NL-14-109

**SUBJECT:** Indian Point Energy Center's Third Six-Month Status Report for the Implementation of Order EA-12-051 Modifying Licenses with Regard to Requirements for to Reliable Spent Fuel Pool Instrumentation (TAC Nos. MF0737 and MF0738)  
Indian Point Unit Numbers 2 and 3  
Docket Nos. 50-247 and 50-286  
License Nos. DPR-26 and DPR-64

ENTERGY'S THIRD SIX-MONTH  
STATUS REPORT FOR THE  
IMPLEMENTATION OF ORDER EA-12-051 MODIFYING LICENSES  
WITH REGARD TO REQUIREMENTS FOR RELIABLE SPENT  
FUEL POOL INSTRUMENTATION

**Figure 1: IP3 SFPI Fan House Cable Routing**

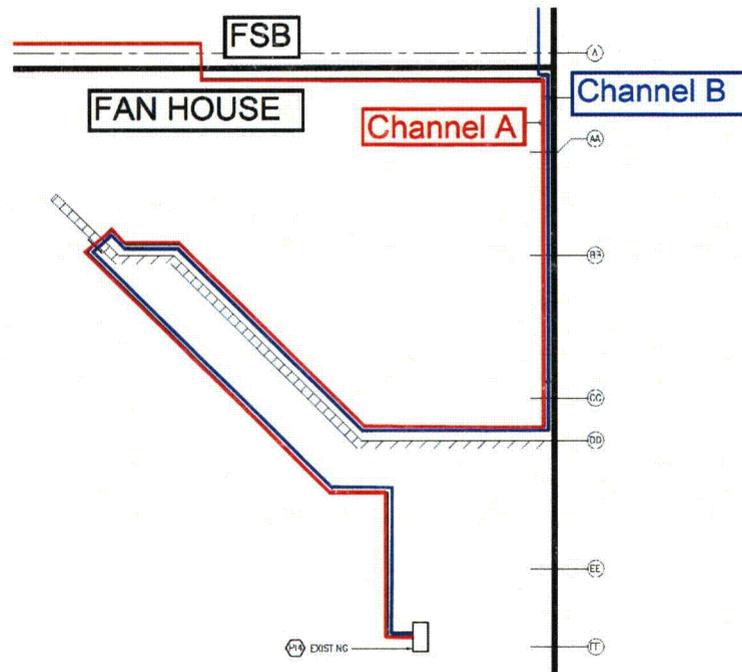
**Please provide a description of the protection provided for the cabling routed along the exterior of the fuel building for Channel B of IP2 and IP3. Also, please provide a sketch to illustrate the remaining cable routing from the fuel building wall penetrations to the processor units for Channel A and Channel B for IP2 and IP3.**

As noted in Sections 4 and 7, the probe locations shown in Attachments 1 and 3 of the OIP have been changed. The Channel A probe is shown where the Channel B probe is located, and the Channel B probe is shown where the Channel A probe is located.

For IP3, Channel A will penetrate through the west wall into the Fan House approximately 30 ft north of the doorway into the Fan House. The Fan House is a Seismic Class 1 structure that is protected against adverse weather conditions. The Channel B route will follow the east wall to the south wall, follow along the south wall and penetrate on the south side of the doorway between the Fan House and the Fuel Storage Building (FSB). Once outside the FSB, the two conduit runs will converge near the door between the FSB and the Fan House. Each channel will maintain plant design channelization requirements by remaining in their dedicated conduits. The two channels will be run down to the 67'-6" Elevation of the PAB Fan House. Both conduits are to be routed through the existing penetration south of the door between the Fan House and the upper mezzanine of the pipe penetration area. Once through the penetration they will be routed down the hall to the Gas Analyzer Rack, which is part of the retired in place Hydrogen Recombiner Panel. The two indicators will be mounted on the panel by removing the retired in place equipment and installing the level indicators. The IP3 SFPI cable routing within the Fan House is shown graphically in Figure 1.
